CITY OF ST. HELENS PLANNING DEPARTMENT STAFF REPORT

Conditional Use Permit CUP.2.25 Sign Permit S.19.25

LOCATION: 1771 Columbia Boulevard; Lots 1-3 and 20-22, Block 145, St. Helens

PROPOSAL: New police station on developed property (existing building to be demolished)

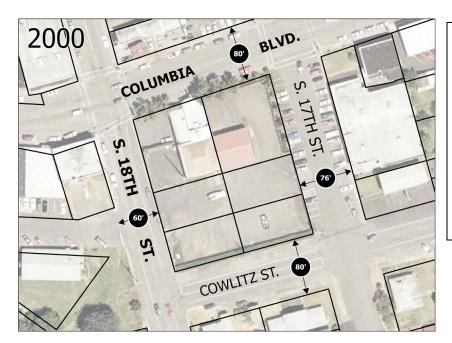
This means the measurement needs to be taken at the widest point within 1' of the fork. DBH at that point appears to exceed 24" DBH, triggering tree plan considerations.

Note that because the branching occurs several feet above ground level, it cannot be considered multistemmed for the purpose of measurement, in which case it would not exceed 24" DBH.

A tree plan can be required when there are more than 10 trees or any trees greater than 24" DBH. Though there are less than 10 trees, one of them appears to exceed 24" DBH.

However, a tree plan can be considered unnecessary, because no tree is proposed to be kept (no protection plan needed) and loss of the five trees tree would require ten replacement trees (2:1 ratio replacement needed when there is retainage of less than 50% of trees) and more than 10 trees are proposed.

To honor this chapter, staff recommends a condition that the final plans have no less than 10 trees. Though, the plans show more than twice that amount, review of construction plans following land use entitlement could result in fewer trees if conflicts not previously identified become evident. Moreover, there are potential street tree conflicts with S. 18th Street as described herein.

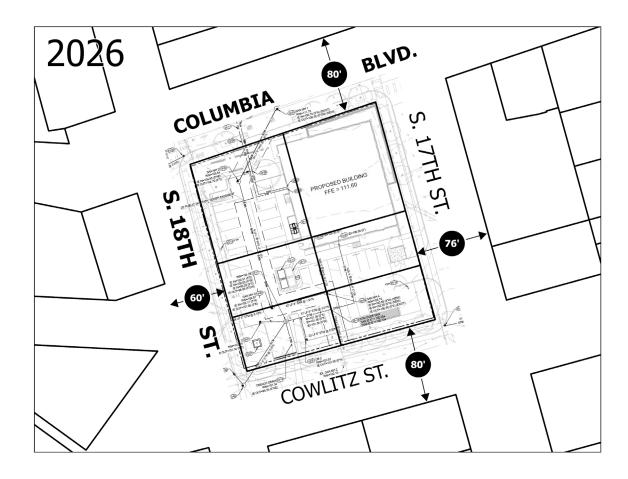
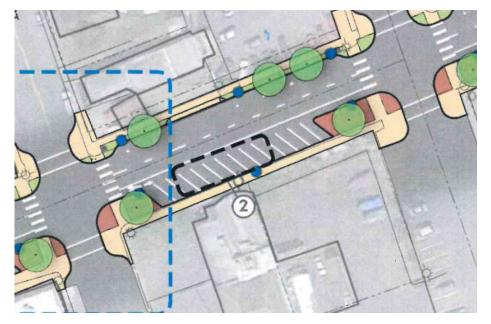
These two exhibits compare existing development and the proposal's development within abutting rights-of-way.

Comparing the 2000 aerial photo (left) with the proposal (below), the back edge of the sidewalk is separated from the property line in the 2026 proposal example with additional landscaping area within the right-of-way.

Top Left: typical collector standard.

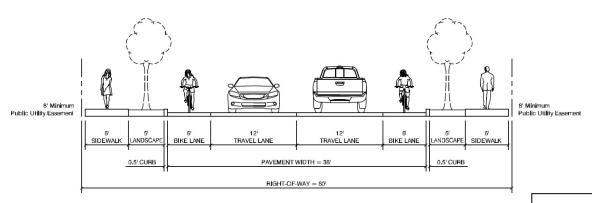
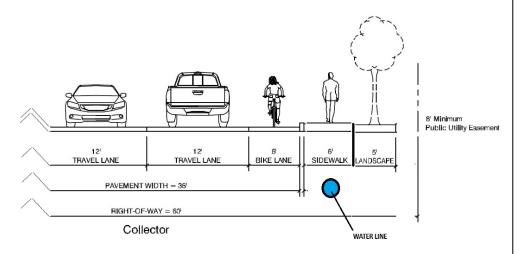
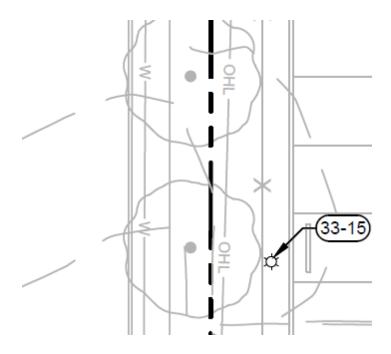
Notes about S. 18th Street: A modified collector street is proposed. Normally, the cross section has a landscape strip with street trees between the curb and sidewalk. However, due to the location of a water line where the trees would normally go, the normal cross section will not work. There are two possible options: rearrange the cross section or no trees.

Rearranging the cross section would involve switching the landscape strip and sidewalk, making the sidewalk curb tight. This is depicted on the plan set submitted for this proposal. Having the landscape strip between the curb and sidewalk helps reduce level of street for sidewalk users along this collector street, so not having that is a consideration. However, trees behind the sidewalk would still be less than 10' from the water line, leaving the other option: keep the cross section as intended with the landscape strip between the street and sidewalk, but no trees. Lower lying and less impactful shrubs could be used, that may not provide shade, but still provide separation from the roadway for sidewalk users.

Does the commission have any recommendation?
